PROJECT REVIEW REPORT

Project ID	4888
Project Name	OYU- Reforesting Uganda for a better tomorrow
Review Type	Registration and Verification
Program(s)	VCS
Verification Period	01-March-2021 - 31-January-2024
Project Proponent	OYU Green Pvt. Ltd.
Methodology	AR-ACM0003: Afforestation and Reforestation of Lands Except Wetlands Version 2.0.
VVB	KBS Certification Services. Ltd.
Assessment Criteria	VCS Standard v4.7
Date of First Issue	19 February 2025
Date of Second Issue	25 July 2025
Date of Third Issue	22 October 2025
Review Conclusion	Approved
Date of Final Issue	26 January 2026

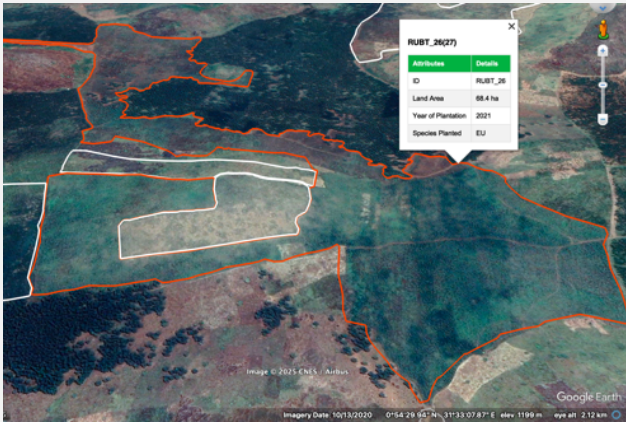
3	Presence of pre-existing plantations before the start date		
	<u>Issue</u> - Satellite images show trees covered several project polygons before the project start date (see background). - Under section 3.1 of the VVR, it is unclear what independent evidence the VVB assessed to confirm the project start date, i.e., when field planting started in the project area. <u>Action Required</u> - The VVB must ensure the PP excludes from the project all polygons with plantations established before the project start date. All the project documentation, including the ERR calculations, must be updated accordingly. - Under Section 3.1 of the VVR, the VVB must specify the independent evidence assessed to confirm the project start date. - The VVB must review the document adjustments and update the VVR accordingly.	Round 1 <u>VVB Response</u> - Audit team reviewed the revised documents and confirmed that all such project polygons showing trees or vegetation cover have been identified and removed along with the one highlighted in the Background (i.e. Polygon RUBT_26, RUBT_63, RUBT_54, RUBT_68 etc). Moreover, the revised project area figures have been applied to the ERR calculations and updated in the PD&MR. Moreover, all project polygons have been checked for any vegetation or tree cover making them ineligible for inclusion. - Section 3.1 of the VVR is updated to include details on the evidence of project start date, independently verified by the VVB. To confirm the project, start date evidence, the project proponent has provided seedling invoice from nursery and then subsequently planting and additionally payment vouchers has been verified. - Audit team reviewed the documents and evidence made updates in the VVR accordingly.	Closed
